Appendix F: Facility Reports

Casa House - Exterior
40 West Olive Street, Madera

Intermodal Facility - Exterior & First Floor
123 North E Street, Madera

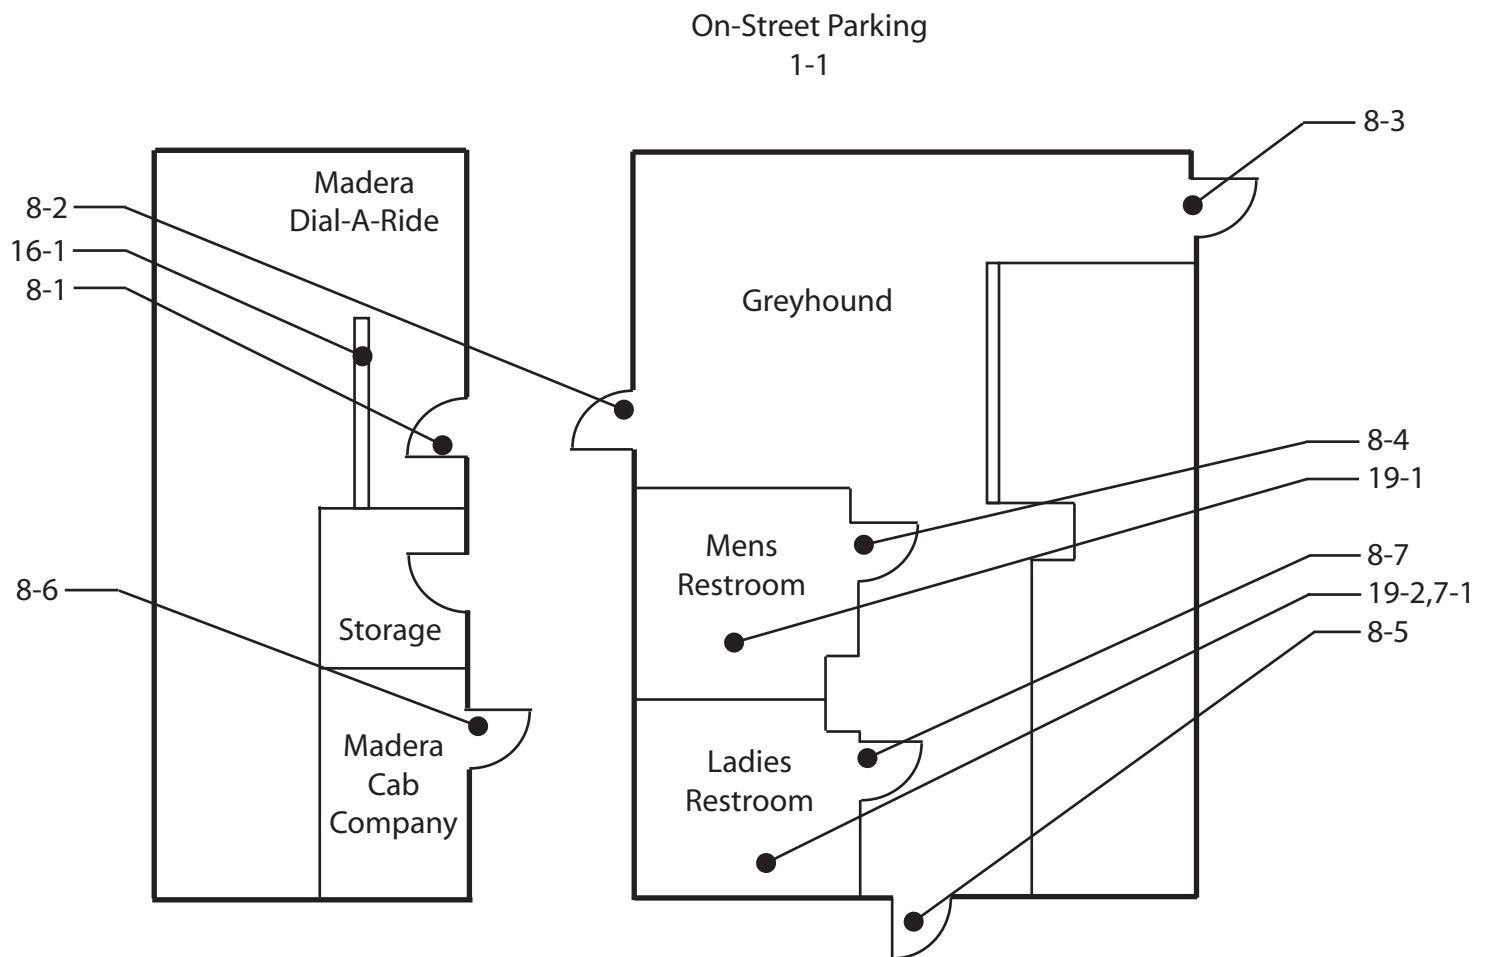
Exterior		
1 - 1	Parking Area	Priority:2
Provide or modify accessible spaces		\$2,950
Notes: Street parking is available, however accessible parking spaces are not. Provide a minimum of one accessible parking space in front of the Intermodal Facility.		
State: 1129B, 1129B.1		
Federal: 4.1.2(5)(b), 4.6.2

Floor 1		
7 - 1	Hazard	Priority: 1
Remove overhanging or protruding objects		\$100
Notes: Towel dispenser protrudes 9.5" (4" max) and is 51" (not between 27" to 80") AFF. Relocate towel dispenser.		
State: 1133B.8.6.1		
Federal: 4.4.1		
8 - 1	Door/Gate	Priority: 1
Provide sign(s) indicating accessible entries and facilities		\$100
Notes: International Symbol of Accessibility is not provided on the door.		
State: 1117B.5.8.1.2, 1127B.3		
Federal: 4.13.6		
Adjust door closer		\$100
Notes: Operating effort is 6 lbs (5 lbs max).		
State: 1133B.2.5		
Federal: 4.13.11		
Install or modify permanent room signs		\$250
Notes: There is an exit sign but Braille is not provided.		
State: 1011.3 #3		
Federal: -		
8 - 2	Door/Gate	Priority: 1
Provide sign(s) indicating accessible entries and facilities		\$100
Notes: International Symbol of Accessibility is not provided on the door.		
State: 1117B.5.8.1.2, 1127B.3		
Federal: 4.13.6

Floor 1		
8 - 7	Door/Gate	Priority:2
Adjust door closer		\$100
Notes: Operating effort is 10 lbs (5 lbs max).		
State: 1133B.2.5		
Federal: 4.13.11		
16 - 1	Transaction Counter	Priority:2
Provide an accessible counter		\$4,000
Notes: Madera Dial-A-Ride: Transaction counter is 42" (28" to 34") AFF.		
State: 1122B.5		
Federal: 4.32.4		
19 - 1	Multiple User Restroom	Priority:2
Replace or reposition dispensers or mirrors		\$250
Notes: Soap dispenser is 52" (40" max) AFF.		
State: 1115B.8.3		
Federal: 4.23.7		
Insulate water lines		\$100
Notes: Drain pipes are not insulated.		
State: 1115B.4.3 #4		
Federal: 4.19.4		
Provide or replace stall door hardware		\$100
Notes: U-shaped handle not provided on back of compartment door.		
State: 1115B.3.1 #4.5		
Federal: 4.13.9		
19 - 2	Multiple User Restroom	Priority:2
Modify lavatory/counter clearances		\$3,500
Notes: Lavatory next to wall has 13" (18" min) between wall and center of fixture.

Madera Municipal Airport - First Floor
4020 Aviation Drive, Madera

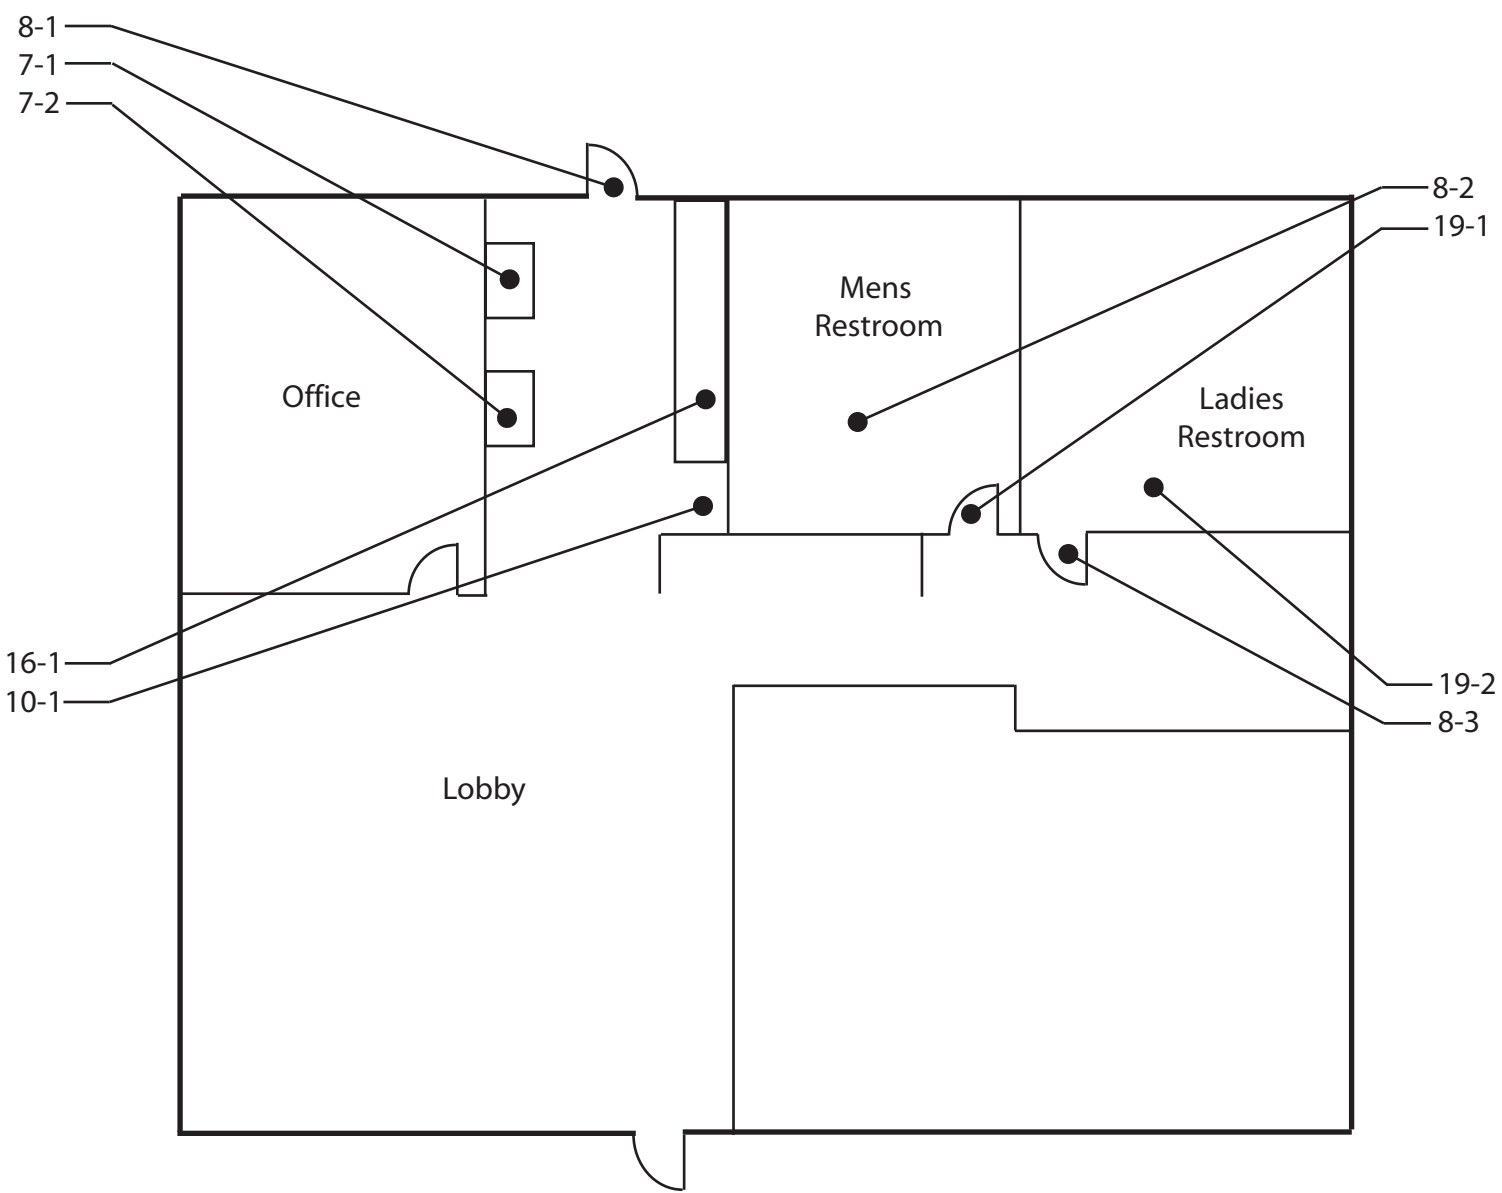
Floor 1		
7 - 1	Hazard	Priority:2
Remove overhanging or protruding objects		\$100
Notes: Work counter protrudes 16" (4" max) and is 33" (not between 27" to 80") AFF.		
State: 1133B.8.6.1		
Federal: 4.4.1		
7 - 2	Hazard	Priority:2
Remove overhanging or protruding objects		\$100
Notes: Work counter protrudes 24" (4" max) and is 36" (not between 27" to 80") AFF.		
State: 1133B.8.6.1		
Federal: 4.4.1		
8 - 1	Door/Gate	Priority:1
Provide sign(s) indicating accessible entries and facilities		\$100
Notes: Accessible entry is not marked by the International Symbol of Accessibility.		
State: 1117B.5.8.1.2, 1127B.3		
Federal: 4.13.6		
Install or modify permanent room signs		\$250
Notes: Accessible permanent room sign stating "Airport Lobby" is not provided.		
State: -		
Federal: 1117B.5.7, 4.30.6		
Adjust door closer		\$100
Notes: Operating effort is 9 lbs (5 lbs max).		
State: 1133B.2.5		
Federal: 4.13.11		
8 - 2	Door/Gate	Priority:2

Adjust door closer		\$100
Notes: Operating effort is 9 lbs (5 lbs max).		
State: 1133B.2.5		
Federal: 4.13.11		
Provide additional strike edge clearance		\$3,000
Notes: Strike-edge clearance on swing-side of door is 9.5" (18" min).		
State: 1133B.2.4.3		
Federal: 4.13.6

Floor 1		
8 - 3	Door/Gate	Priority: 2
Adjust door closer		\$100
Notes: Operating effort is 9 lbs (5 lbs max).		
State: 1133B.2.5		
Federal: 4.13.11		
Increase or provide maneuvering or clear floor area		\$2,500
Notes: Level space on the swing-side of the door is 47.75" (60" min).		
State: 1133B.2, 1133B.2.4.2, 1133B.7.5		
Federal: 4.13.6		
10 - 1	Drinking Fountain	Priority: 3
Replace or reposition drinking fountain		\$3,500
Notes: Hi-low fountain not provided. Clear knee space is not provided. Bubbler height and control are 40" (36" max).		
State: 1115B.4.6 #1, 1115B.4.6 #2, 1115B.4.6 #4, 1117B.4.6 #2		
Federal: 4.1.6, 4.15.2, 4.15.5		
16 - 1	Transaction Counter	Priority: 2
Provide an accessible counter		\$4,000
Notes: Work counter is 39" (28" to 34") AFF.		
State: 1122B.5		
Federal: 4.32.4

Notes: Mens Restroom - Mirror is mounted so bottom of reflecting surface is 44.5" (40" max) AFF.		
State: 1115B.8.1		
Federal: 4.19.6		
Replace or reposition urinal		\$1,500
Notes: Mens Restroom - Urinal is 27.5" (17" max) from the floor to the lip. Flush control is 52" (44" max) AFF.		
State: 1115B.4.2 #1, 1115B.4.2 #2		
Federal: 4.18.2

Floor 1		
19 - 1	Multiple User Restroom	Priority: 2
Provide or replace stall door hardware		\$100
Notes: Mens Restroom - U-shape handle not provided on the back. Compartment door not self-closing.		
State: 1115B.3.1 #4.5		
Federal: 4.13.9		
Replace or reposition dispensers or mirrors		\$100
Notes: Mens Restroom - Coat hook is mounted 67" (48" max) AFF.		
State: 1118B.5		
Federal: A4.27		
Replace or reposition fixtures		\$1,000
Notes: Mens Restroom - Space from the wall to the centerline of the toilet is 17.25" (18" absolute).		
State: 1115B.7.1.3		
Federal: 4.17.3		
Modify stall partitions and doors		\$500
Notes: Mens Restroom - Space from the wall to the side of the toilet is 15" (32" min).		
State: 1115B.4.1 #1		
Federal: 4.17.3		
Modify stall partitions and doors		\$500
Notes: Mens Restroom - Compartment width is 39.5" (60" min).		
State: -		
Federal: 4.17.3		
Reposition toilet flush controls		\$750
Notes: Mens Restroom - Flush control not on wide side.

Floor 1		
19 - 1	Multiple User Restroom	Priority:2
Replace or reposition dispensers or mirrors		\$100
Notes: Mens Restroom - Seat cover dispenser is 56" (40" max) AFF.		
State: 1115B.8.3		
Federal: 4.23.7		
Replace or reposition dispensers or mirrors		\$200
Notes: Mens Restroom - Toilet paper dispenser is 37" (36" max) from the back wall.		
State: 1115B.8.4		
Federal: 4.16.6
